SUBJECT: BEAVER VALLEY POWER STATION, UNIT NOS. 1 AND 2 (BVPS-1 AND 2) -
ISSUANCE OF AMENDMENTS RE: CONTAINMENT CONVERSION FROM
SUBATMOSPHERIC TO ATMOSPHERIC OPERATING CONDITIONS
(TAC NOS. MC3394 AND MC3395)

Enclosures: 1. Amendment No. 271 to DPR-66
2. Amendment No. 153 to NPF-73
3. Safety Evaluation

Figure 1: Integrated Energy Release

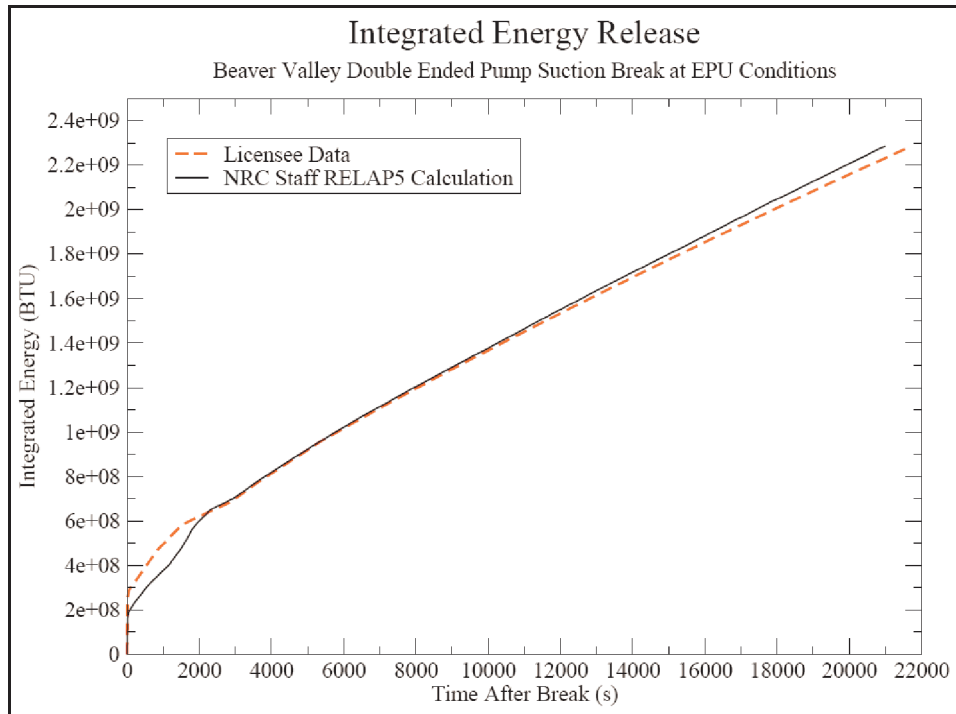
Figure 1 shows that the two calculations are in agreement for the integrated energy release. At the beginning of the transient up to about 2000 seconds, the licensee's calculation is higher than the the NRC staff's. This is most likely due to the modeling convention taken by the licensee in which the release of the metal mass energy is assumed to occur very early in the transient while the NRC staff's calculation assumes a more gradual release. At 6 hours the NRC staff's calculation is about 2 percent higher than the licensee's.

Figure 2: Long Term Mass Release Rate

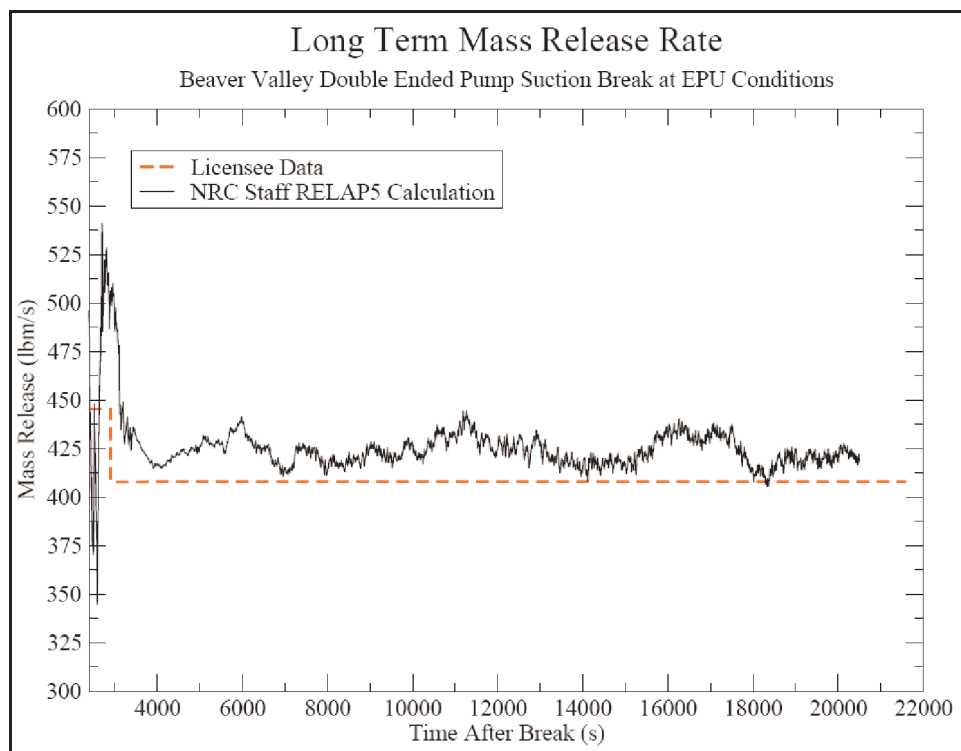
Figure 2 shows relatively close agreement between the licensee and the NRC staff's calculations. The differences are most likely due to the assumptions used in the calculation of mass release. The licensee used the last value of 408 lbm/sec from the calculation in Enclosure 2 to the licensee's June 2, 2004, letter, which ended at 3600s. When calculating the recirculation injection rate, the NRC staff converted the value given in the licensee's April 13, 2005, letter, from gallons-per-minute to pound-mass-per-second using 62 lbm/ft³ as the density of water. Given that the sump conditions change over time, the density of water could be lower. This could cause the NRC staff's calculated mass release rate to be lower by as much as 10-20 lbm/s.

Figure 3: Long Term Energy Release Rate

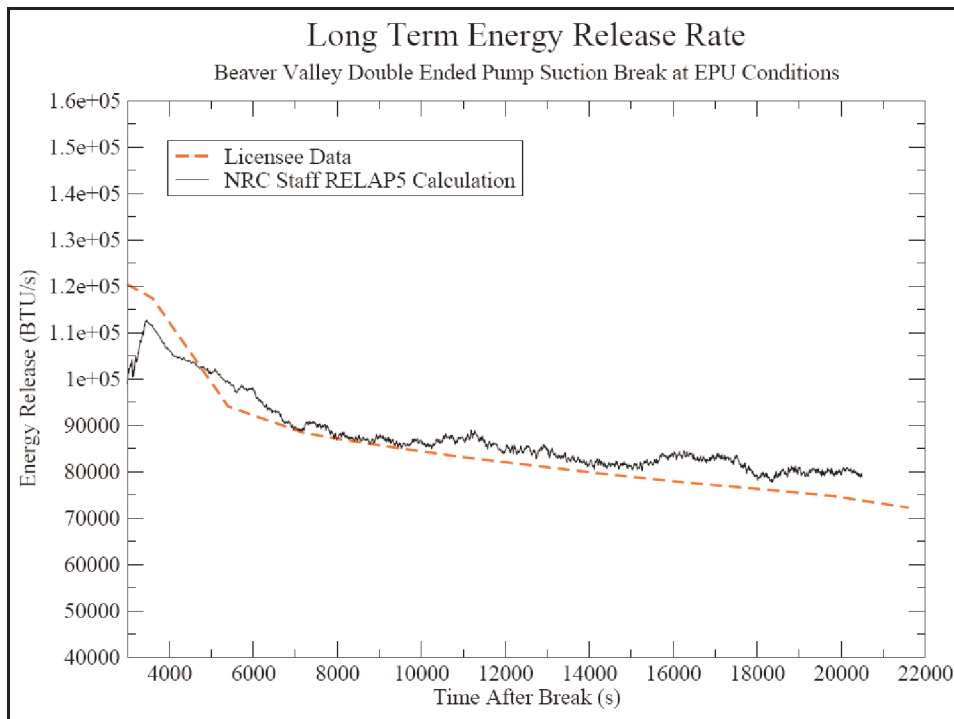
Figure 3 shows good agreement between the licensee and the NRC staff's calculations. At about 16,000 seconds the NRC staff's calculation is about 4 percent higher than that of the licensee's, however, this may be due to the higher mass release calculated by the NRC staff which is also about 4 percent higher.

Figure 4: DEHL Break Energy Release Rate

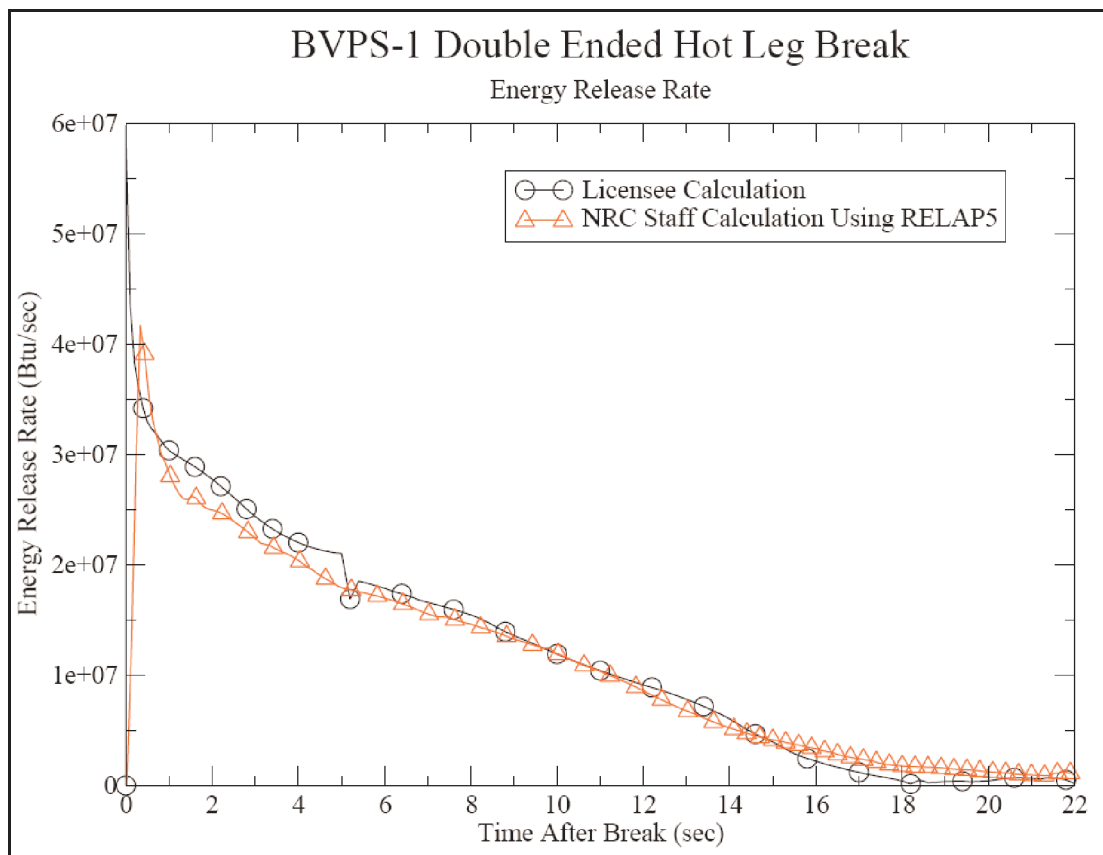
the vessel side and the pump side of the break in the discharge leg. The NRC staff's calculation shows close agreement with the licensee's analysis.

Figure 5: DEHL Break Mass Release Rate

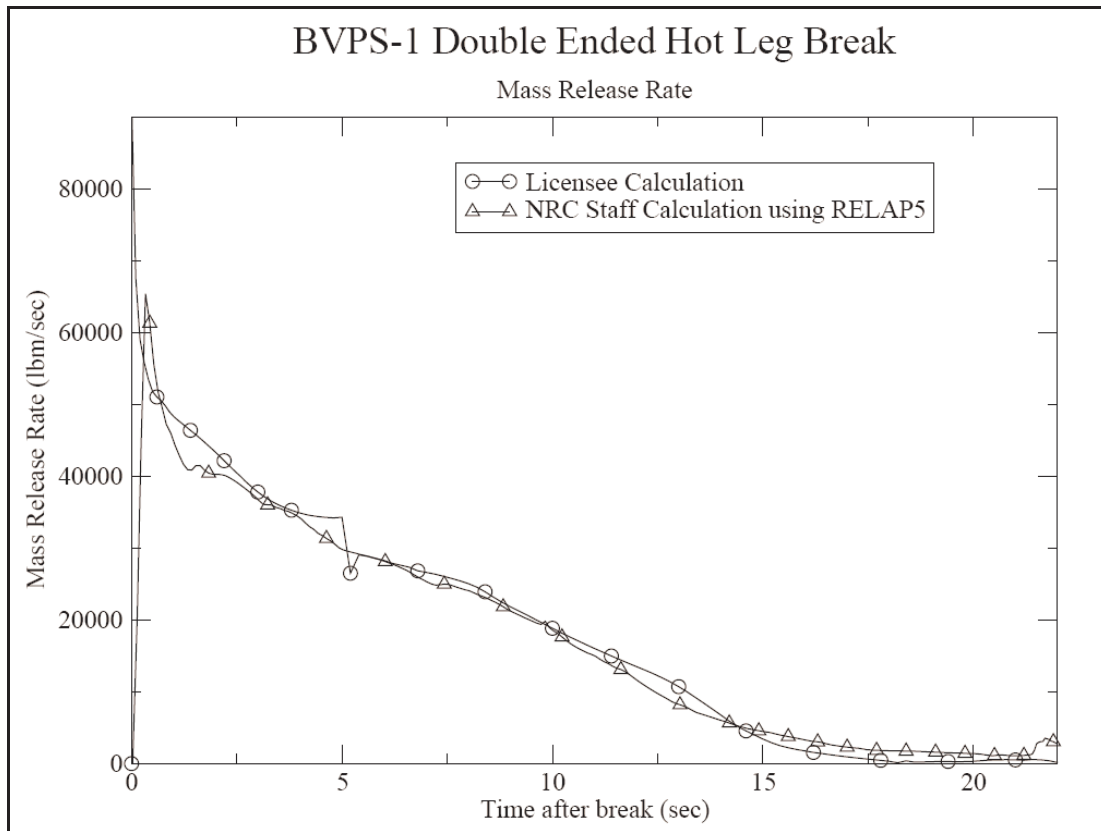
Figure 5 shows the energy release rate as a function of time for the blowdown phase of the DEHL break compared to the licensee's calculation. The x-axis shows time after the break in seconds, the y-axis shows the sum of energy release rates from the vessel side and the pump

side of the break. The licensee's and NRC staff's calculation of the energy release rate for the DEHL break show close agreement.

Figure 6: DEPS Break Mass Release Rate (0 to 25 seconds)

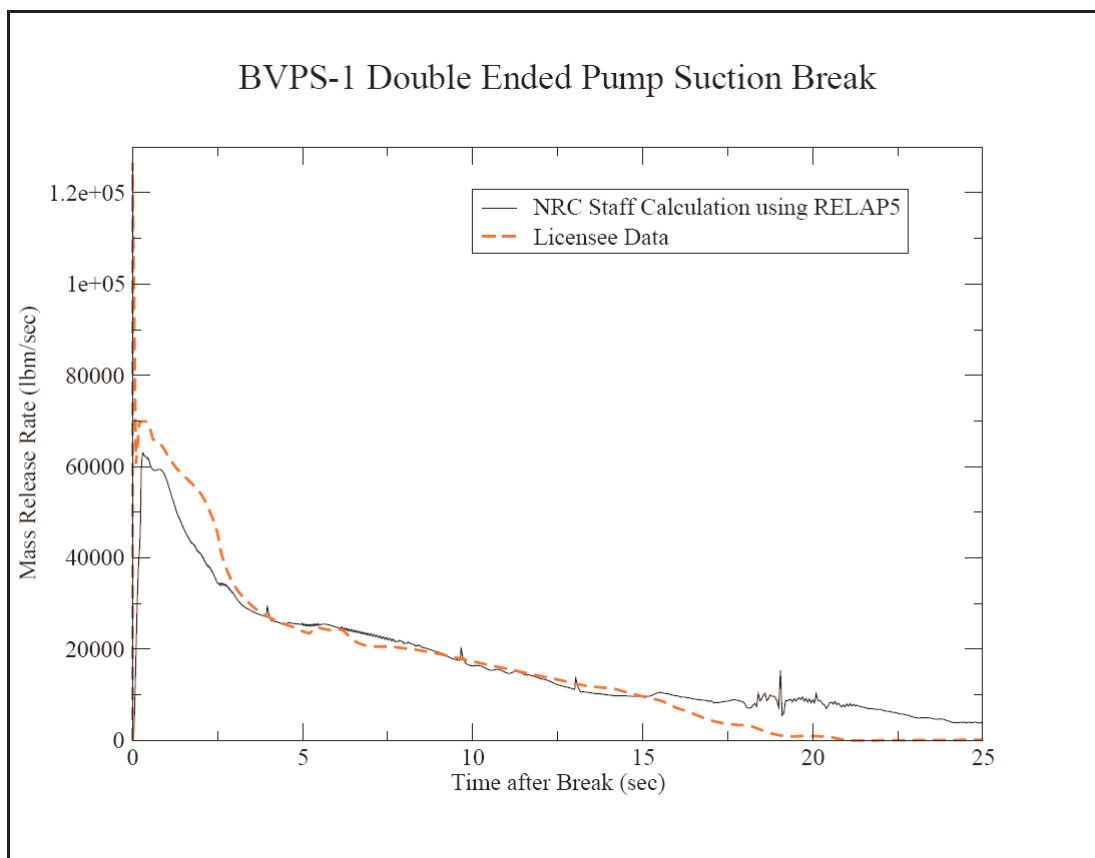
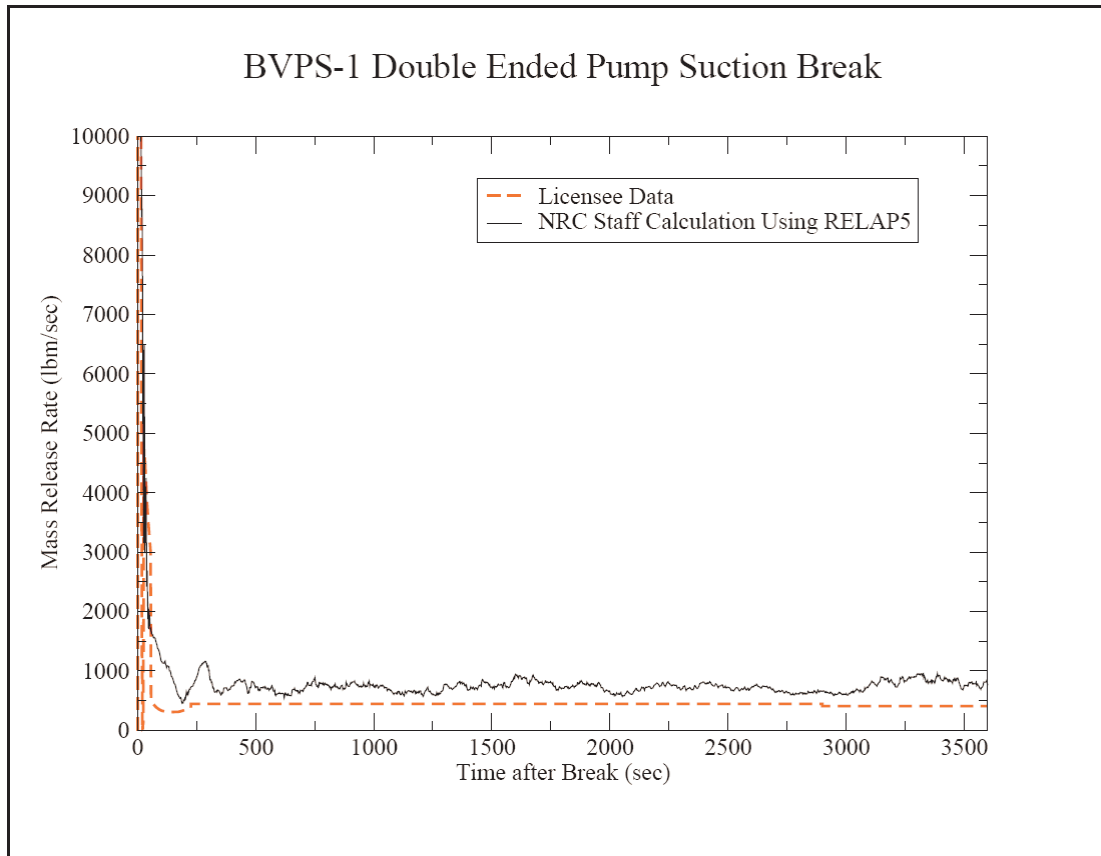
Figures 6 and 7 demonstrate that the mass release rate calculated by the licensee is in relatively close agreement with the NRC staff's calculation. In the long term, the mass release rate calculated by the NRC staff was higher than that of the licensee's calculation by about 50 percent. This is expected since the assumptions used by the NRC staff in the injection rate were also about 50 percent higher.

Figure 8: DEPS Break Energy Release (0 to 25 seconds)

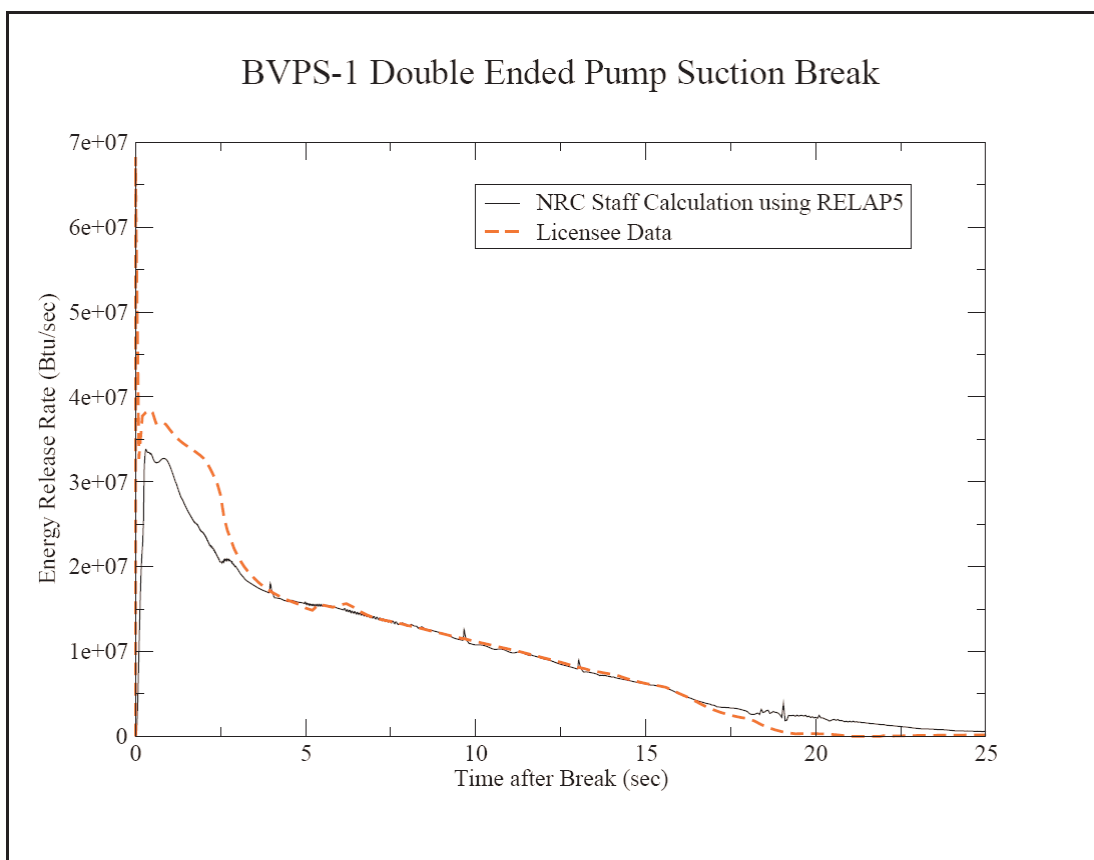
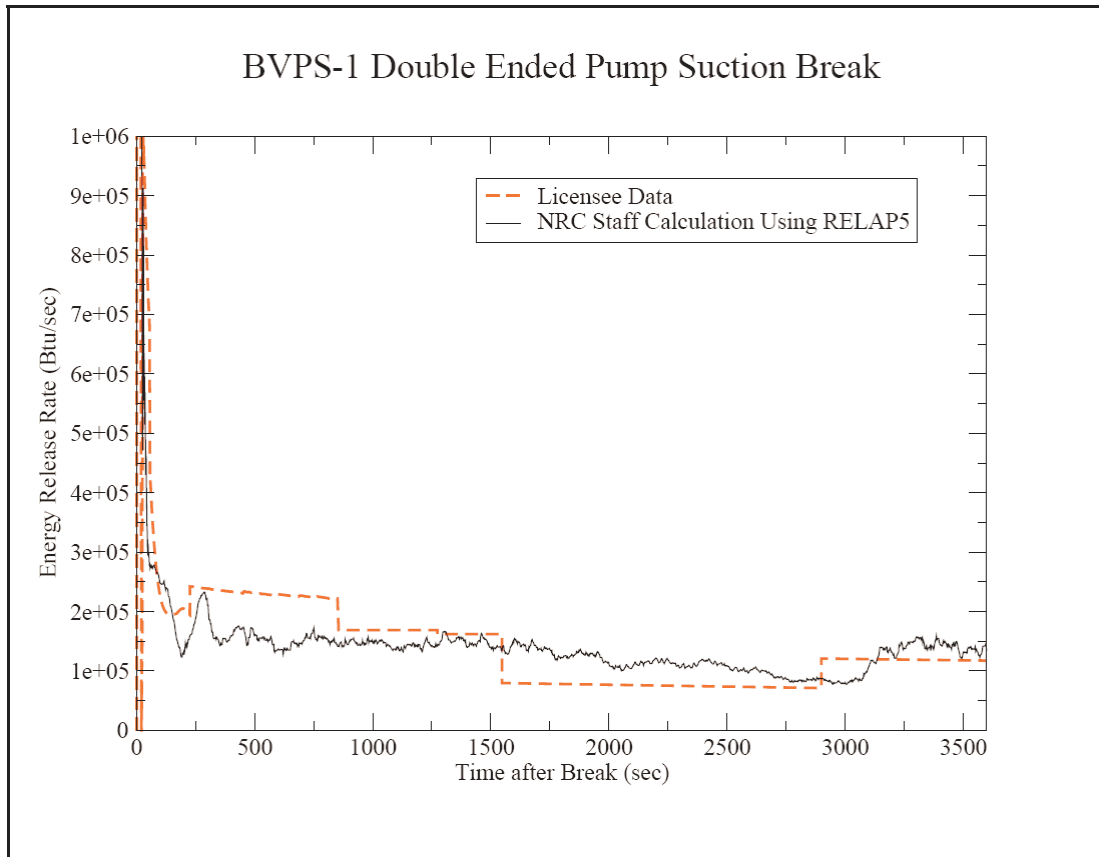
Figures 8 and 9 show the energy release rate as a function of time calculated by the NRC staff compared to the licensee's calculation. Figure 8 shows the blowdown in the first 25 seconds of the event. Figure 9 shows the longer term energy release rate up to 3600 seconds into the event. For both plots, the x-axis shows time after the break in seconds, the y-axis shows the sum of the energy release rates from the SG side and the pump side of the break in the suction leg.

Figures 8 and 9 demonstrate that the energy release rate for the DEPS break calculated by the licensee agrees relatively well with the NRC staff's calculation despite the NRC staff using conservative decay heat and higher injection flow rate assumptions.
